# United States Department of the Interior

3482  
U-0147570  
U-0142235  
(U-065c)

RE: Skyline Mine No. 3 Resource Recovery and Protection Plan  
(R2P2) Modification - Changes in Recoverable Reserves and  
Shortening of the 6th Right Longwall Panel

UTAH FUEL COMPANY  
SKYLINE No. 3 MINE  
LOWER O'CONNER A SEAM  
6th RIGHT PROJECTION  
ENCLOSURE 2

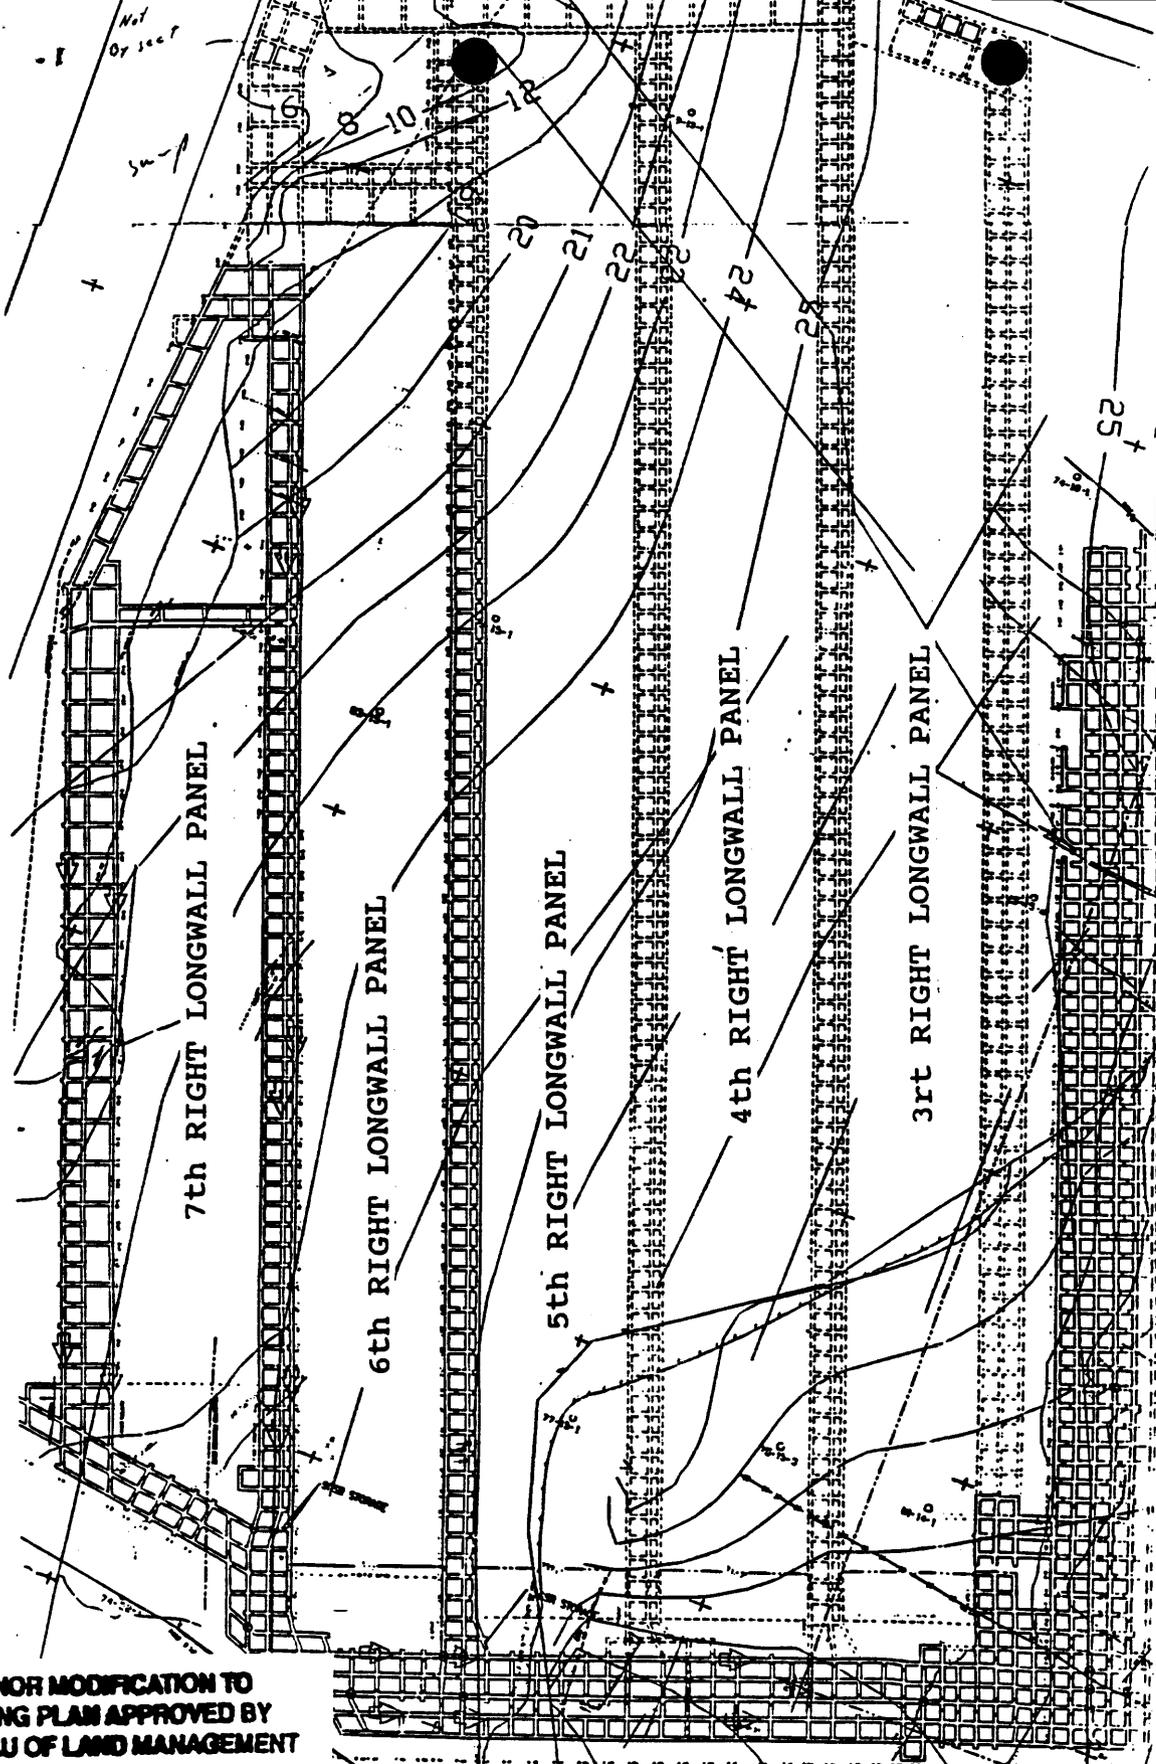
UFC's approved mining plan was to develop the 6th Right headgate entries to the bleeder entries and install the 6th Right longwall panel at #73 crosscut (please see enclosure #2). They are requesting a change in this plan. The longwall set-up entry will now be at #67 crosscut and the block of coal between #67 and #73 crosscuts (herein referred to as perimeter entries) will be first mined only.

According to UFC, a recent geologic study of the rock splits in the northwest corner of Federal coal lease U-0147570 indicates that the coal thickness is below the minimum thickness requirements to mine with the new longwall equipment. The perimeter entries will be developed to use as a long-term sump and for ventilation purposes.

During an inspection on December 16, 1991, A. Elias verified that the newly installed longwall equipment's minimum mining height is 7 feet. In the 7th Right Headgate section, rock splits were observed in all three entries in the section. In the 6th Right Headgate section, the same rock split was observed. The entries were dipping down in a northwest direction at about a 6 percent slope (visual observation). Additionally, a fault zone was observed in the 6th Right Headgate section. The zone was approximately 250 feet wide.

A file search was conducted at the Price Coal Office by A. Elias. UFC has conducted a Very Low Frequency geophysical analysis of the subject area. From this analysis, rock splits were indicated in a northeast direction and the fault zone trends approximated N60W. This geophysical analysis verified that the coal thickness isopachs between #68 and #73 crosscuts of the 7th Right headgate entries are less than 7 feet.

In summary, due to reduction in the seam thickness, the new longwall equipment cannot be used to mine the perimeter entries. Rock splits, fractures and faults have also been noted in this area. The area will be developed with a continuous miner and used as a sump, since the 6th Right Headgate entries are dipping downslope. Since the area is at a depth of 2300 feet, pillaring is not feasible due to the safety issues. Shortening the 6th Right longwall panel to accommodate the new mining equipment will reduce the estimated recoverable reserves for the Federal coal lease U-0147570 by the amount of 80,000 tons.

The BLM has determined that the mine plan changes are in compliance with the Mineral Leasing Act of 1920, as amended, the regulations at 43 CFR 3480, the lease terms and stipulations, and will achieve maximum economic recovery of the Federal coal. As a result of these modifications the recoverable coal reserves for Skyline Mine No. 3 will increase by 1.37 million tons. Therefore, the BLM will allow the mine plan changes. The copies of the approved mine maps are enclosed.

UTAH FUEL COMPANY  
 SKYLINE No. 3 MINE  
 LOWER O'CONNER A SEAM  
 PROJECTION MAP  
 ENCLOSURE 1

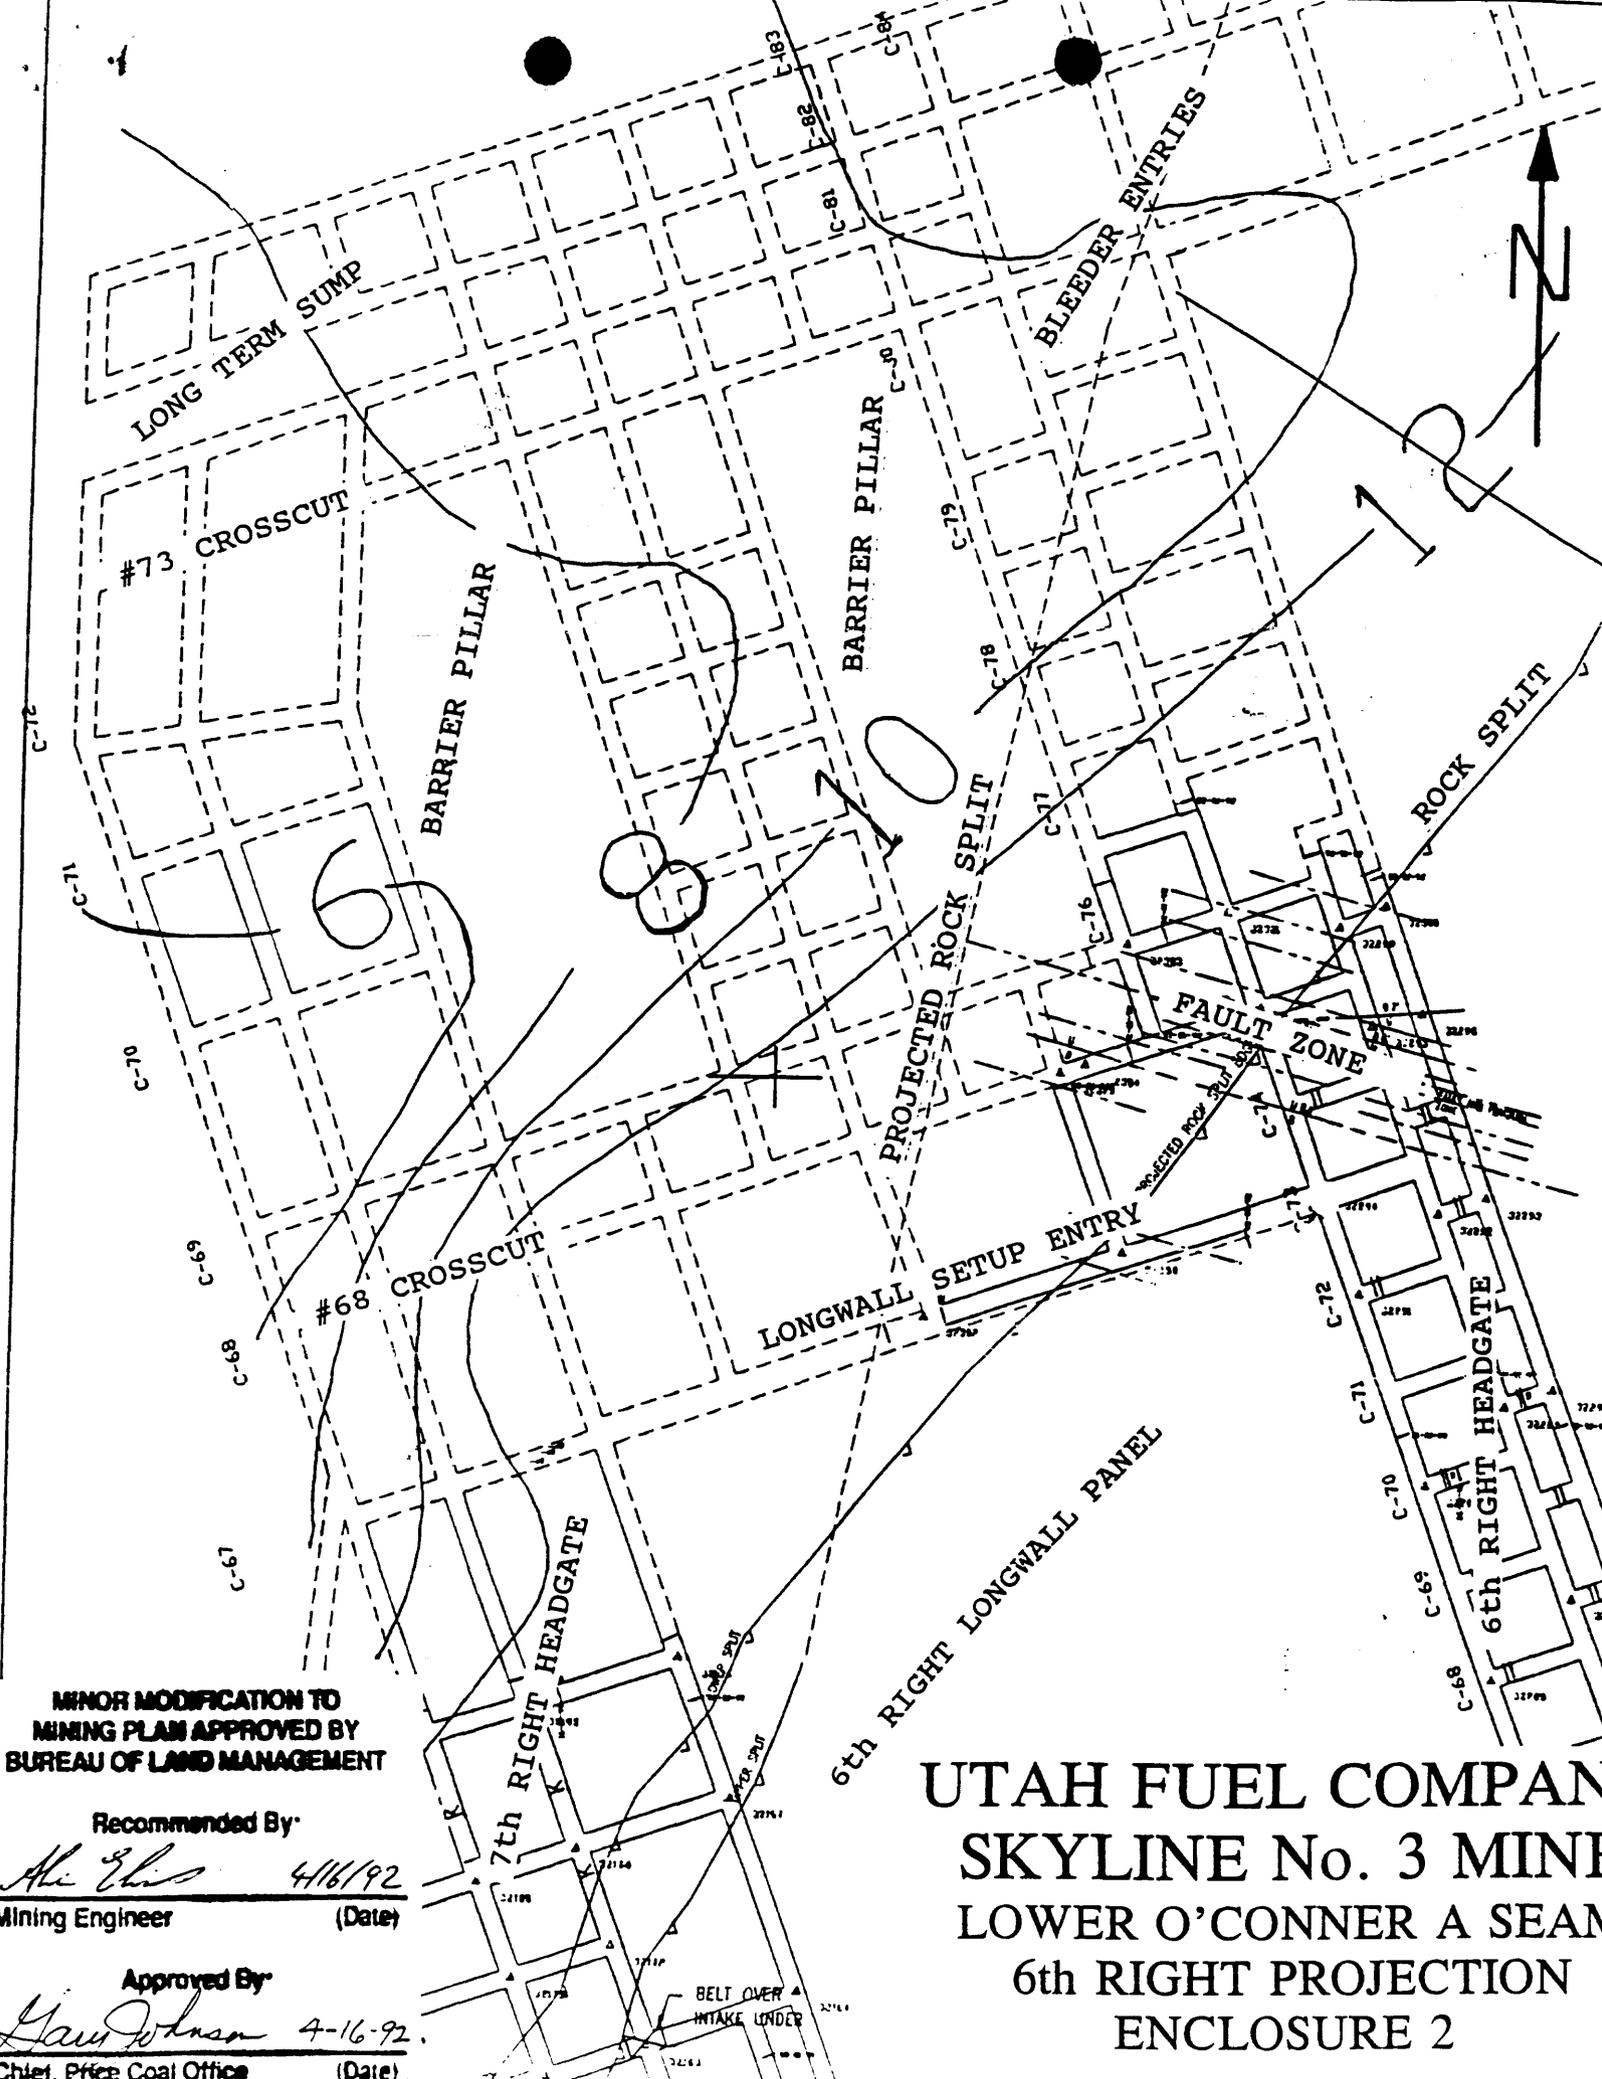
The original recoverable reserve estimate for the Skyline Mine No. 3 was based on a maximum mining height of 13 feet. UFC is requesting to change this estimate to a maximum mining height of 15 feet for longwall panels 3rd, 4th, 5th, 6th and 7th Right as conditions allow (please see enclosure 1). This change is requested because UFC has recently purchased new longwall mining equipment.

As a result of the new mining height, UFC has recalculated the recoverable reserves. A. Elias performed independent calculations to verify these estimates. The results are listed in a chart below.

The above calculations indicate that UFC is estimating the recoverable reserves 8.2 percent lower than the BLM estimates. These differences are reasonable. As a result of this modification, the recoverable reserves for Federal coal leases U-0147570 and U-0142235 will increase by 1.45 million tons.

MINOR MODIFICATION TO  
 MINING PLAN APPROVED BY  
 BUREAU OF LAND MANAGEMENT
